Technical Bulletin

TB20240821
 2024/8/22

Subject: Notice of replacing RC2-A/B-F with RC2-A/B-P.

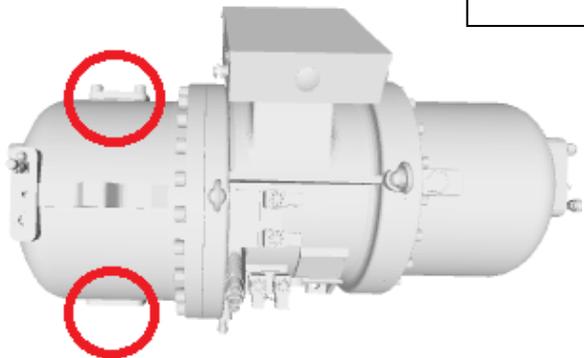
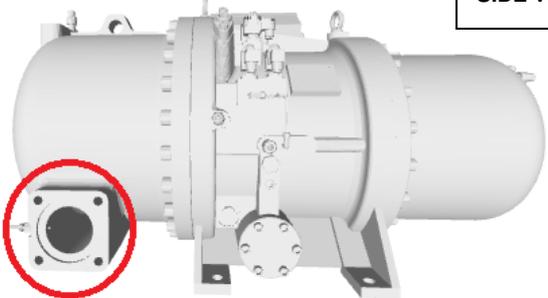
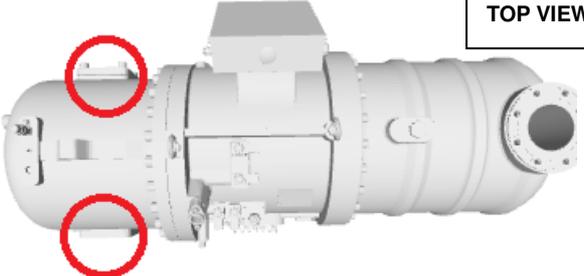
Starting from September 1st 2024, RC2-100A/B-F ~RC2-1530A/B-F series (WITHOUT internal oil separator) will be cancelled and replaced with RC2-A/B-P series. The original discharge port of RC2-F series is on the axial direction, but the discharge ports of RC2-P series are located on both of the lateral directions. Installers can choose either port to weld the discharge pipe for more convenient piping work.

1. In future retrofit cases when old RC2-F compressors need to be changed, Installers needs to change the discharge piping design on old chillers/ refrigeration units. Or, RC2-P compressors can be re-assembled with old axial-direction port oil separator assemblies at service stations before compressor installation on old chillers/refrigeration units.
2. For future service part inquires, Hanbell will stop providing axial-direction port oil separator casings/assemblies from September 1st 2024.
3. For layout of new chillers/refrigeration units, Hanbell will provide 3D drawings of all RC2-P models for your reference.
